DIST	COUNTY	ROUTE	KILOMETER POST TOTAL PROJECT	SHEET No	TOTAL SHEETS
04	SF	80	13.2/13.9	132R2	1204

REQUEST FOR INFORMATION NOT ADDRESSED IN THIS CCO REMAIN IN FORCE					
MARK	DATE	DESCRIPTIONS	BY	CH'D	CCO#
2	02/19/08	ELECTRICAL MODIFICATIONS	MP	RR	42
1	10/16/06	REVISED SHEET NOTES	LR	MG	11
REVISIONS

**DETAILS**  
**SAS SUPERSTRUCTURE ROADWAY WESTBOUND**  
**CONDUIT LOCATIONS**  
SCALE AS NOTED  
**E-67**

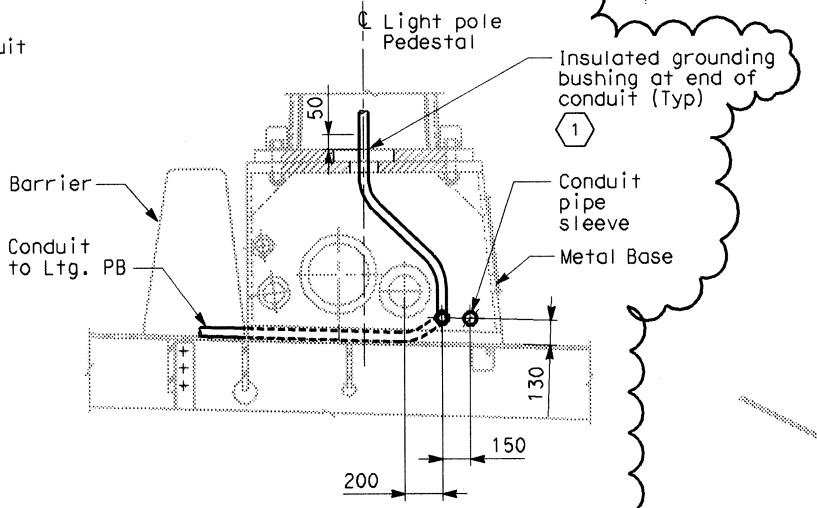
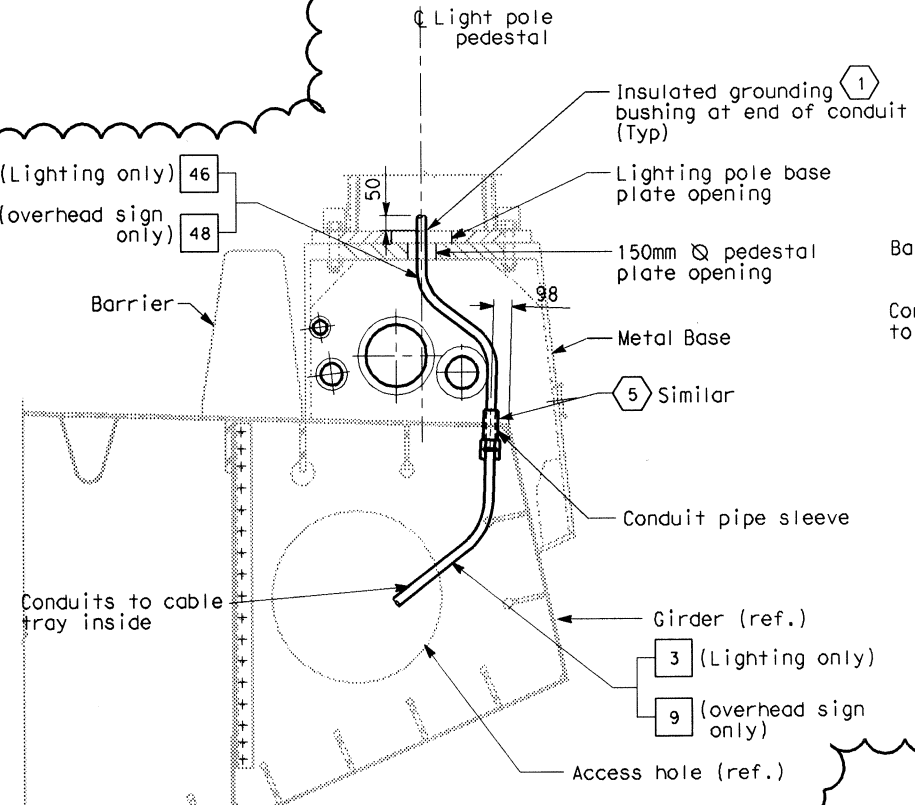
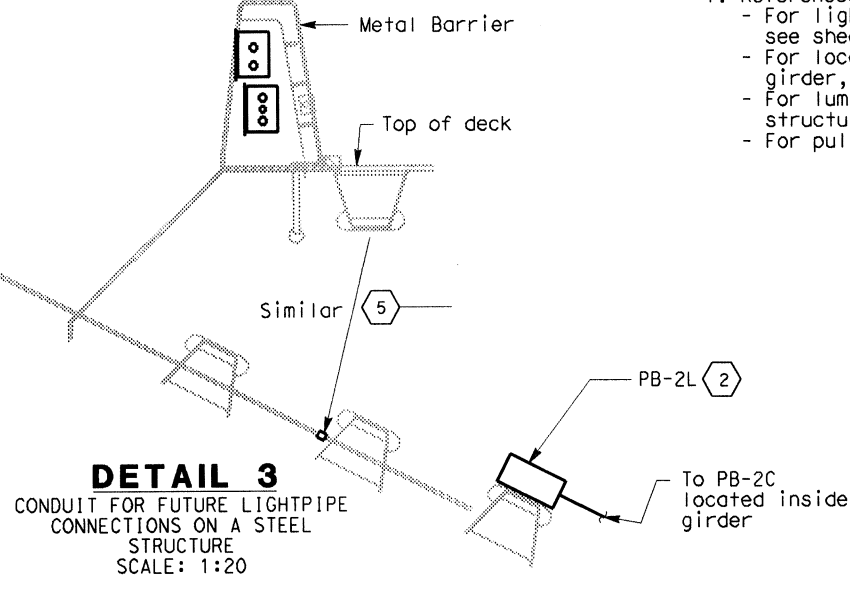
- SHEET NOTES:**
- 1 Bond grounding bushing to ground lug of lighting pole with #6 bare copper wire.
  - 2 Conduits for future light pipe shall continue from this pull box.

- 3 Conduit shall be clear of all piping and pipe sleeves. Route conduit on top of deck plate, outside of girder box.
  - 4 For pylon floodlighting layout, see sheets E-47 & E-48.

- 5 See Utility Detail No. 1 (Sheet No. 965 of 1204) for conduit penetration through girder plate and lighting pole metal base. The Contractor shall install sealant between the sleeve and conduit for future light pipe, plug and cap sleeve to prevent water or moisture from passing inside the sleeve.
